Tanzila Textile Ltd. (Extension)

22 January 2024

2. Observations:

Observation-1: Discrepancy in as-built drawing (Store Building)

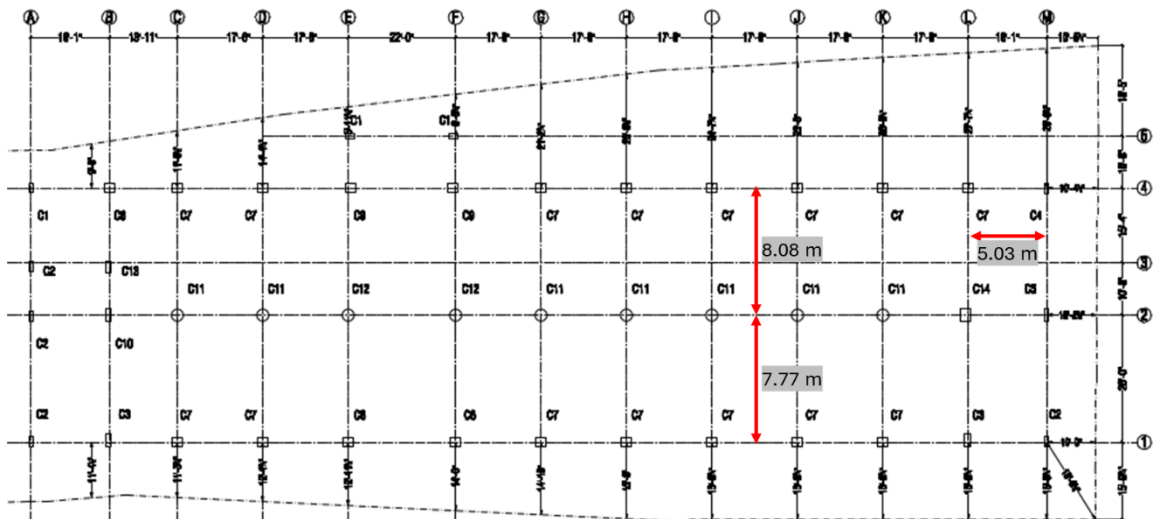
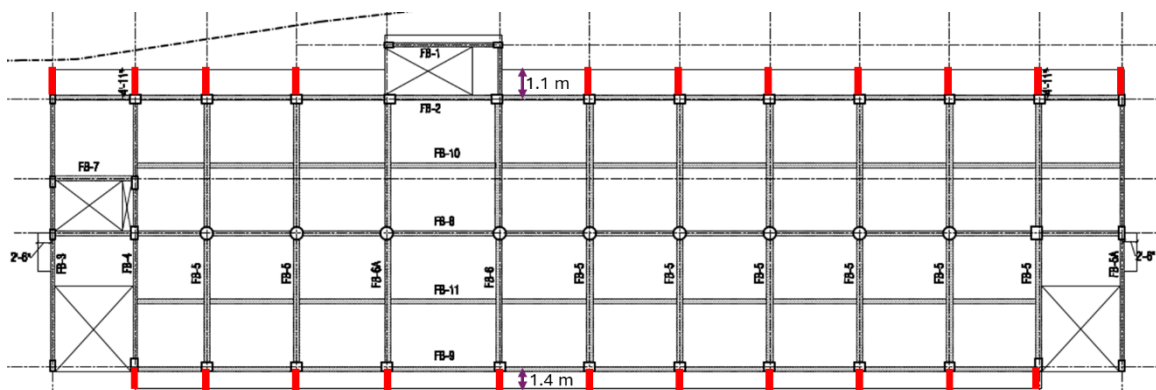
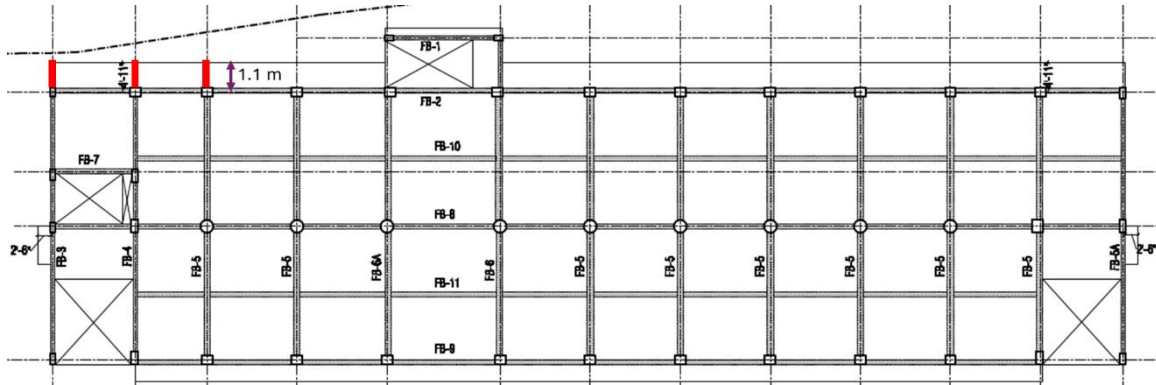
Floor buildup in toilet

Mismatch in grid distance

Cantilever beam in 4th and 5th floor

Cantilever beam in 2nd floor

Cantilver portion

Beam offset from column center

Description: During inspection, 250mm floor build up found in toilet areas of 1st and 2nd floor. Mismatch in grid distance was found at GL 1-2, GL 2-4 and GL L-M. In drawing, no cantilever beam is shown but cantilever beams were found on-site at 2nd, 4th and 5th floor. In drawing, no beam is shown offset to columns but during inspection, beams offset to columns were found at ground floor. The building engineer is required to survey the structure, prepare accurate as-built drawings and update the design report and FEM accordingly.

Observation-3: Water ponding at roof (Store Building)

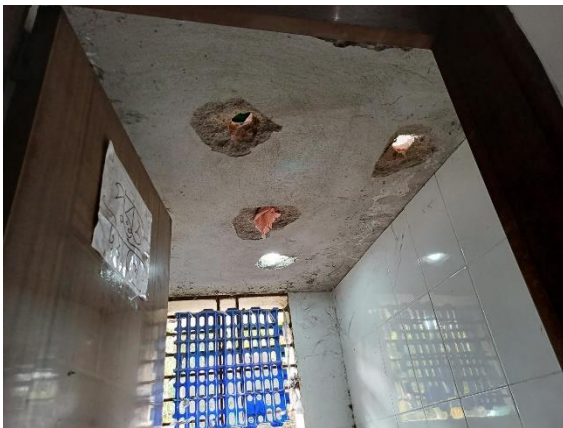
Description: During inspection, water ponding was found at the roof. The building engineer is required to improve the drainage system by providing adequate slopes and outlets to prevent water ponding.

Observation 6: Mismatch in as-built drawings (Knitting Shed)

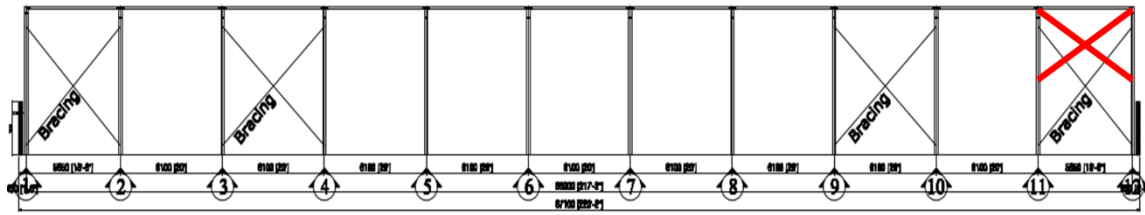
Mismatch in side wall bracing section

Missing drawing of steel canopies

Description: During inspection, mismatch was found in the side wall bracing section. No canopy is shown in the drawing, but during inspection, two canopies were found on-site. The building engineer is required to survey the structure, prepare accurate as-built drawings and update the design report and FEM accordingly.

Observation 7: Significant gap in connection (Knitting Shed)

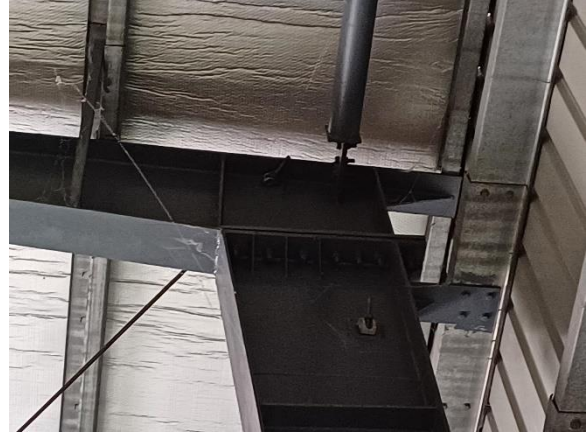
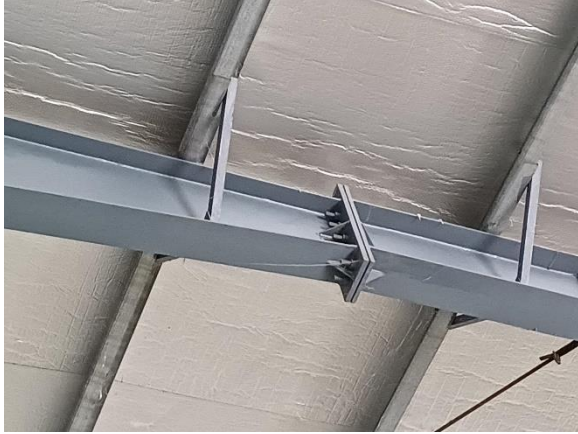
Description: Significant gaps in the connections of the rafter to the column and rafter to rafter were found. The building engineer is required to identify the locations of the connection gaps, and repair the gaps with a suitable method.
